### APPEAL SUMMARY

**Status:** Decision Rendered - Reconsideration of ID 26419

<b>Appeal ID:</b> 26449	<b>Project Address:</b> 1784 NW Northrup St
<b>Hearing Date:</b> 1/26/22	<b>Appellant Name:</b> Tiffonie Carroll
<b>Case No.:</b> B-008	<b>Appellant Phone:</b> 5034847745
<b>Appeal Type:</b> Building	<b>Plans Examiner/Inspector:</b> John Cooley
<b>Project Type:</b> commercial	<b>Stories:</b> 7 <b>Occupancy:</b> B, M, R-2, S-2 <b>Construction Type:</b> Type I-A and Type III-A
<b>Building/Business Name:</b> North 18	<b>Fire Sprinklers:</b> Yes - throughout
<b>Appeal Involves:</b> Erection of a new structure	<b>LUR or Permit Application No.:</b> 20-161043-CO
<b>Plan Submitted Option:</b> pdf [File 1] [File 2] [File 3]	<b>Proposed use:</b> multifamily

### **Omission of fire rated construction of Level 3, Type IIIA roofed trellis: Granted as proposed.**

9 SECTION - SOUTH WALL AT TRELLIS  
3/4" = 1'-0"

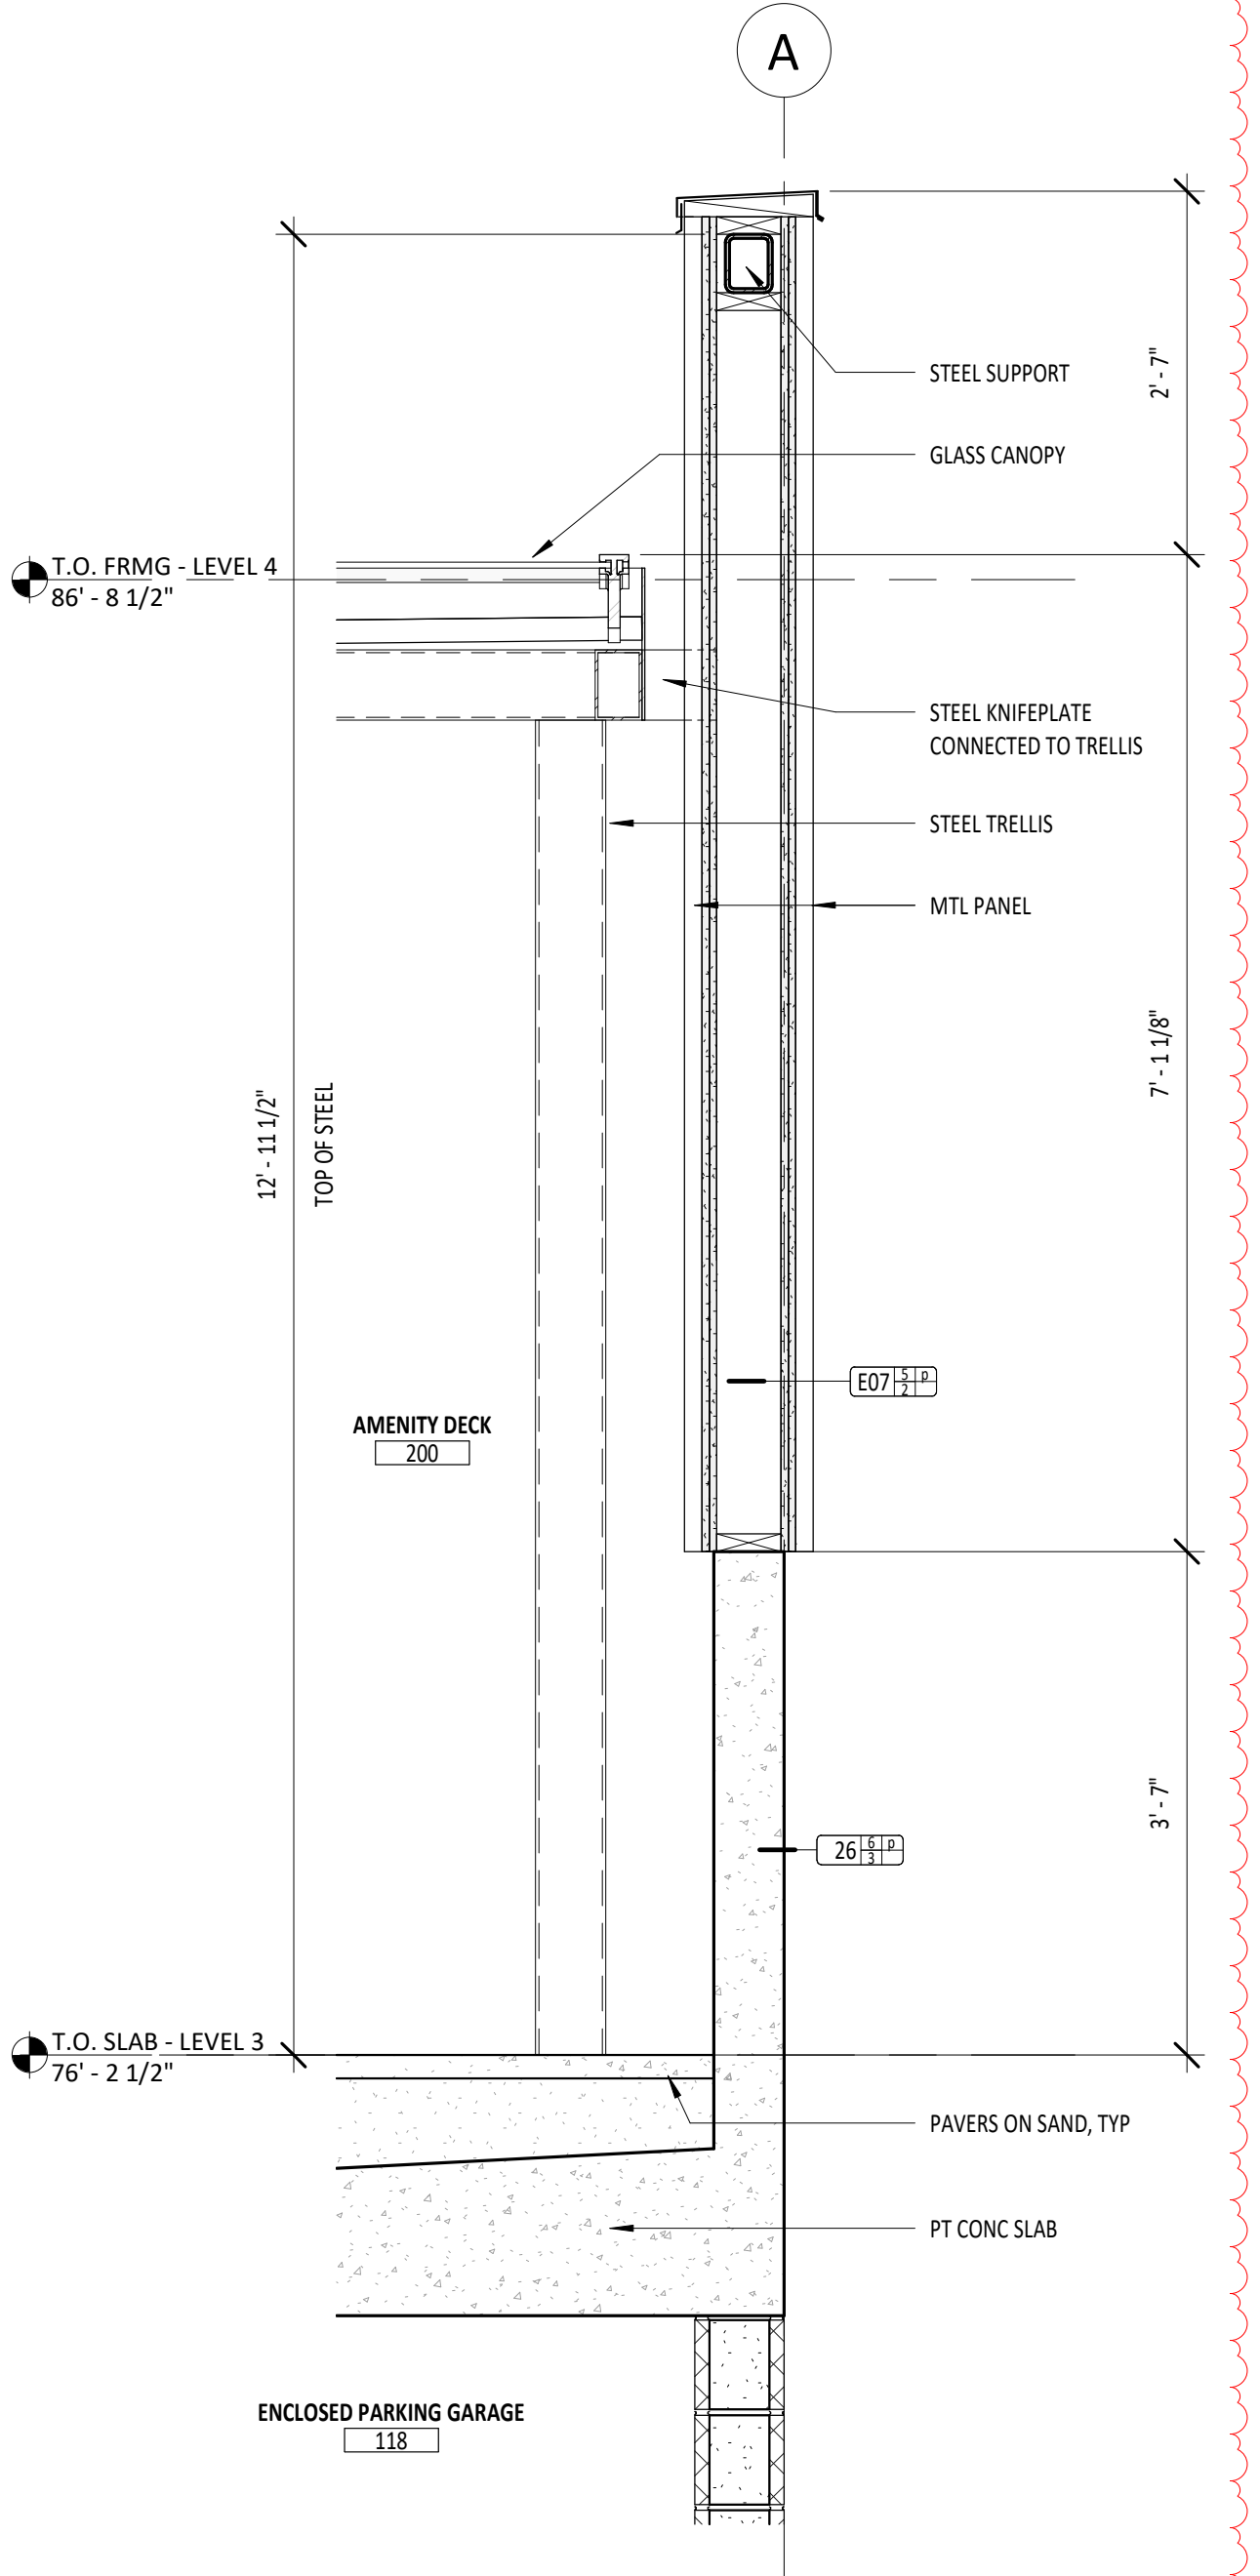
<b>Code Section</b>	2019 OSSC Table 601
<b>Requires</b>	Table 601: Primary structural frame for Type III-A is required to be 1hr construction.
<b>Code Modification or Alternate Requested</b>	We ask that the primary structural frame for the amenity deck trellis not be required to be 1hr construction, and instead to be non-combustible.
<b>Proposed Design</b>	<p>Building Construction at levels 1 &amp; 2 are construction Type I-A. Levels 3 thru 7 are Type III-A. Occupancy at the amenity deck on level 3 is A-3. The building is fully sprinklered. The level 3 deck is 2hr rated concrete with sand and pavers.</p> <p>The trellis canopy structure at level 3 is open on 3 sides, and has a glass canopy for about 165 sf (the entire amenity deck is about 2267 sf). The glass canopy is 10' above finish floor, and is open on 3 sides: total open area is over 400 sf of open area, more than 2.5x the area of the glass canopy. Sprinklers for the trellis are not required nor proposed.</p> <p>The small glass canopy is provided as a rain cover for the bbq's and a few tables so the deck can be useable during inclement weather.</p> <p>The trellis is made of steel and glass (noncombustible), and is supported by HSS 6x6x5/16 columns. There is a 2hr rated wall at the south end of the trellis that extends 2'-6" above the highest point of the glass canopy (only 1hr is required per table 602).</p> <p>The trellis structure is isolated from the building structure and only supports trellis components.</p>

<b>Reason for alternative</b>	Our trellis is not constructed over exterior walls, has no roof deck, nor thermal barriers. It has low risk of heat and smoke containment due to the fact that it is open on 3 sides.

The trellis columns should not be required to be rated because in the event of a fire people will not congregate below the 165sf canopy – they will walk towards the exits and evacuate the deck. There are no walls restricting egress nor smoke at the trellis. We propose protection to the south with a 2hr wall (1hr required) and to construct the trellis and canopy with non-combustible materials. In the event of a fire at the neighboring property the area beneath the trellis will be protected and people can evacuate the amenity deck via the 2 egress paths provided.

The Administrative Appeal Board finds that the information submitted by the appellant demonstrates that the approved modifications or alternate methods are consistent with the intent of the code; do not lessen health, safety, accessibility, life, fire safety or structural requirements; and that special conditions unique to this project make strict application of those code sections impractical.
